RFT# 4239 - Addendum #2 Heat Pumps and Electrical Service Bicentennial School

To: All Bidders
Date: May 30, 2024
From: Nancy Rideout, Purchasing Manager
Office: (902) 464-2000 ext. 2222
Email: nrideout@hrce.ca

PROJECT
BICENTENNIAL SCHOOL - HEAT PUMPS AND ELECTRICAL SERVICE

5 EQUIPMENT SUPPORT PLAN - GYMNASIUM AREA
SCALE: 1/4"=1'-0"

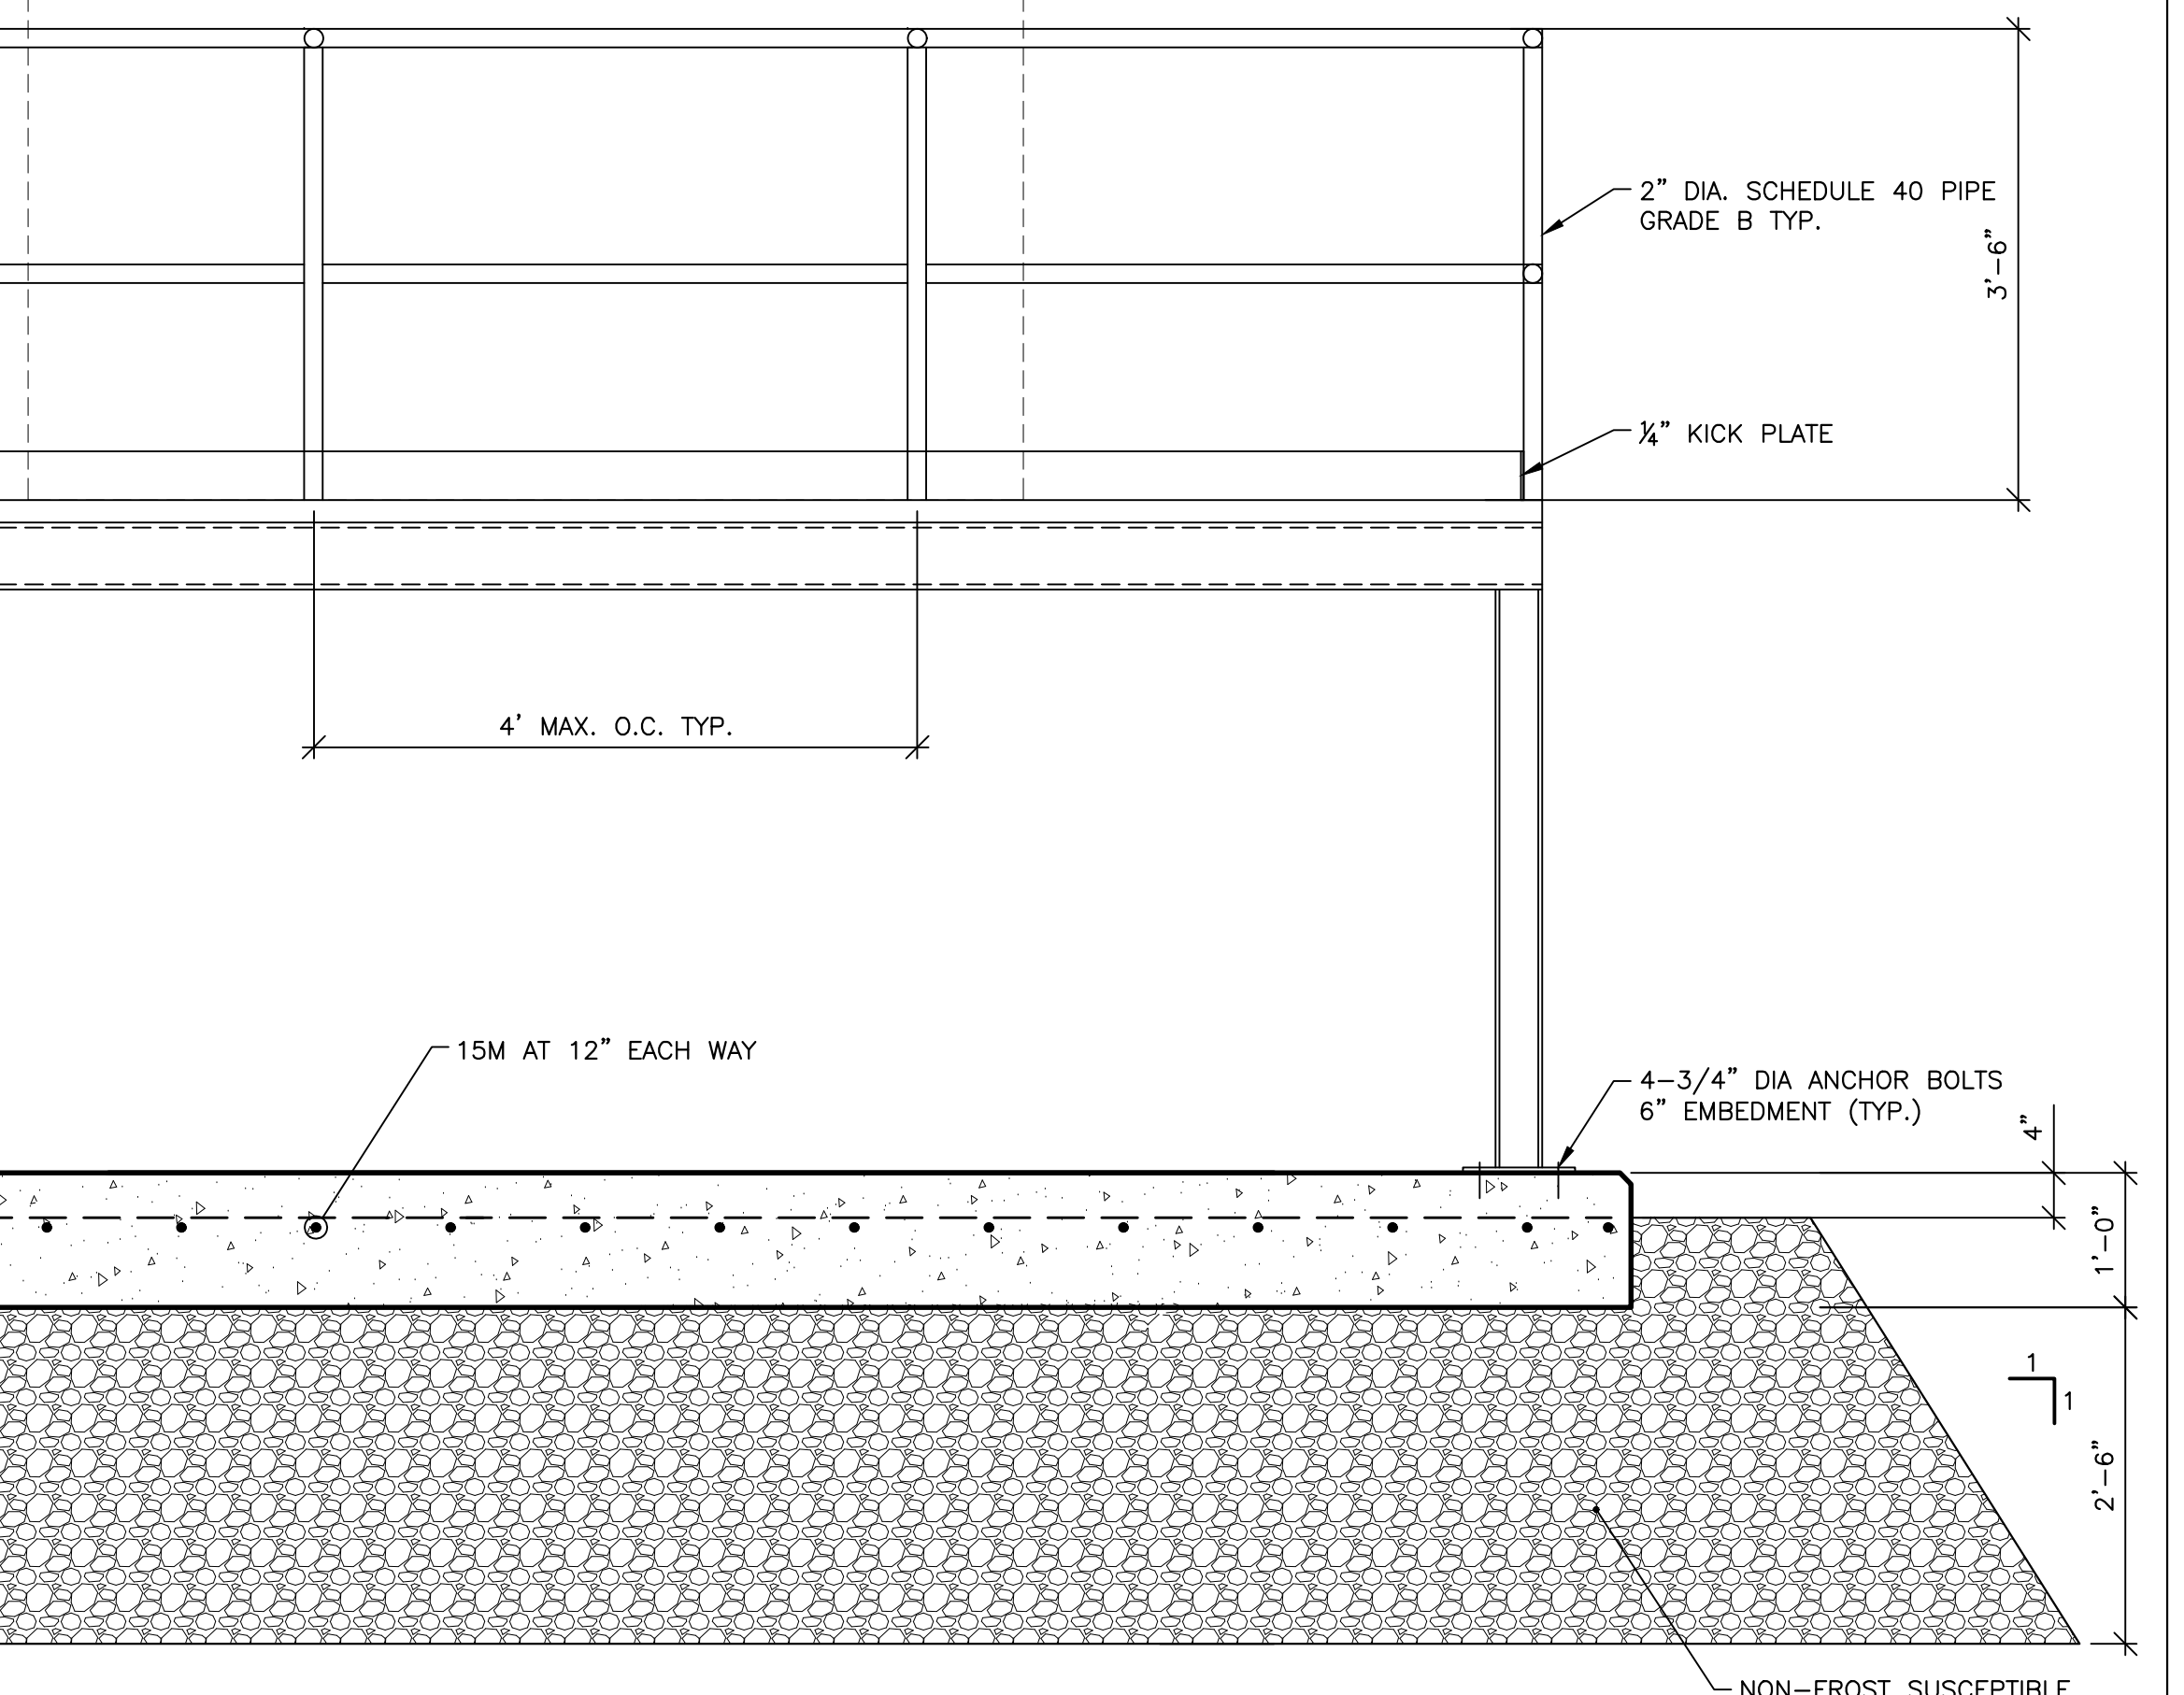
(Part 3) On drawing MV-104, there is a note regarding the structural stand for AC-1 to see structural drawings for information. Assuming the stand is part of this tender package, please provide structural drawings.

(Part 3) Structural drawings are included with this addendum. Refer to "Additional Information" at the end of Addendum #1.

- 1) Structural drawing S101.1 STRUCTURAL DETAILS – Enclosed – 24 MAY 2024
